TECHNICAL SERVICE BULLETIN																			
DATE ISSUED		MODEL YEAR(S) AFFECTED		MODEL(S) AFFECTED		TSB #													
3/24/08		2006-2007		All Newmar DP on Spartan MM Chassis		335													
BRAND						TYPE													
All	<input type="checkbox"/>	American Star	<input type="checkbox"/>	Mountain Aire	<input type="checkbox"/>	All	<input type="checkbox"/>	T T	<input type="checkbox"/>										
Cypress	<input type="checkbox"/>	Dutch Star	<input checked="" type="checkbox"/>	Kountry Aire	<input type="checkbox"/>	F W	<input type="checkbox"/>	C A	<input type="checkbox"/>										
Northern Star	<input type="checkbox"/>	Kountry Star	<input checked="" type="checkbox"/>	Essex	<input type="checkbox"/>	D P	<input checked="" type="checkbox"/>	D B	<input type="checkbox"/>										
Scottsdale	<input type="checkbox"/>	King Aire	<input type="checkbox"/>	London Aire	<input type="checkbox"/>														
All Star ME	<input checked="" type="checkbox"/>	Ventana	<input checked="" type="checkbox"/>

RSB07-500-002

RECALL SERVICE BULLETIN

- SUBJECT:** Power Distribution – Bussmann® (DVEC) Dual Vehicle Electrical Center.
- APPLIES TO:** Certain Spartan Chassis Models Manufactured from July 5, 2006 t

FIG. 2-1

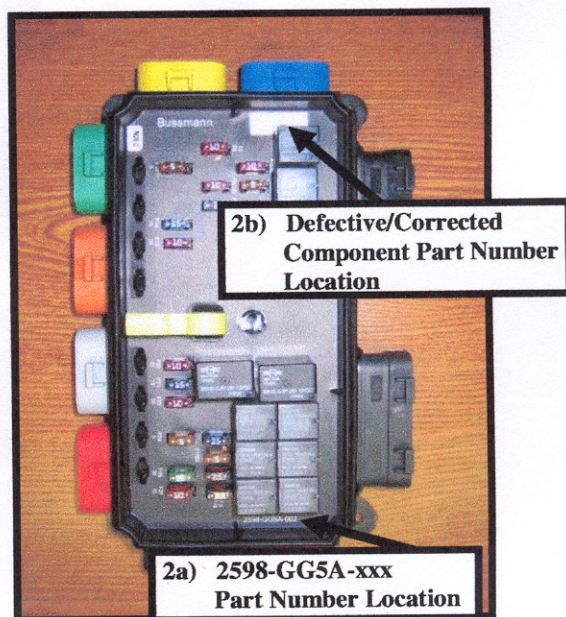
1. Observe all industry safety standards, disconnect any necessary power source and secure vehicle to allow for replacement of the Bussmann® DVEC at the rear PDC (Power Distribution Center).
2. Locate the rear PDC near the engine, generally on the passenger side between the rear wheels and the rear of the vehicle.
 - 2a. Refer to FIG. 2-1. Identify the DVEC having a part number beginning with 2598-GG5A. The part number is located on the inside cover and on the lower right inside face of the box.
 - 2b. Refer to FIG. 2-1, 2-2 & 3-1. The DVEC having a part number in the top right corner of the box ending in a -1 is defective and must be replaced with a box where this number ends in -2 as shown in FIG. 3-1.

CORRECT BUSSMANN® DVEC SHOWN
FIG. 3-1

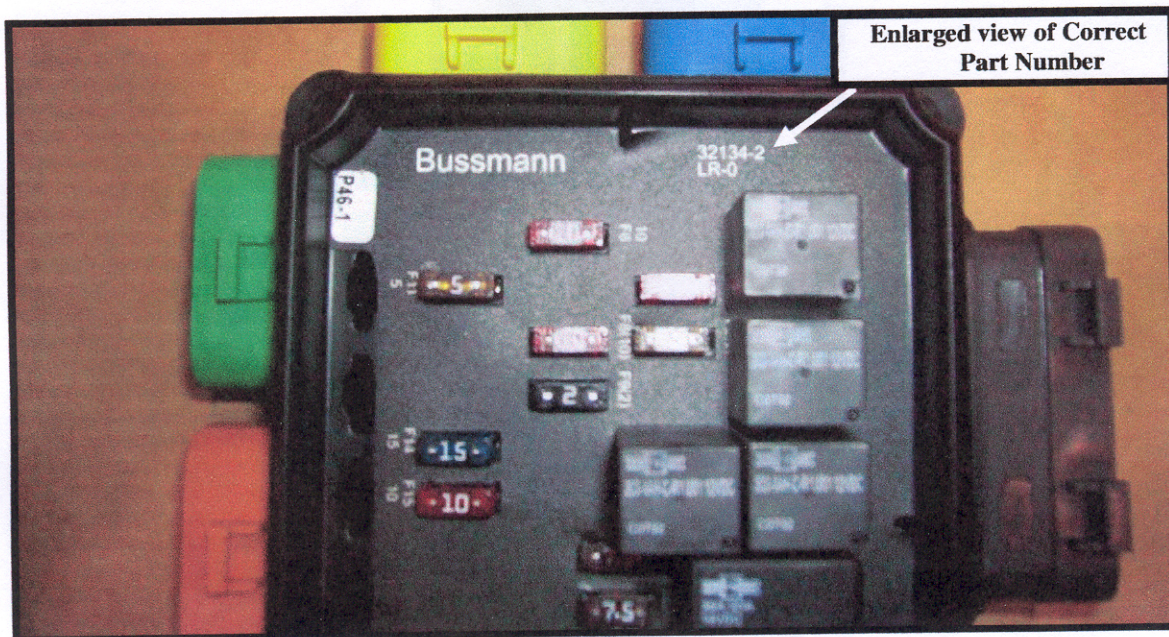
- CAUSE:** Loose jumper connection inside the Bussmann® DVEC
- CORRECTION:** Replace Bussmann® DVEC.

3. Disconnect the electrical connectors to the DVEC and remove the 4 fasteners attaching the DVEC to the mounting surface. Retain mounting fasteners for reinstallation. Replaced DVEC must be returned to Spartan Chassis Inc.

4. Attach the DVEC to the mounting surface using the fasteners removed in step #3.
5. Connect electrical connectors to the new DVEC.
6. Reconnect any power source previously disconnected.
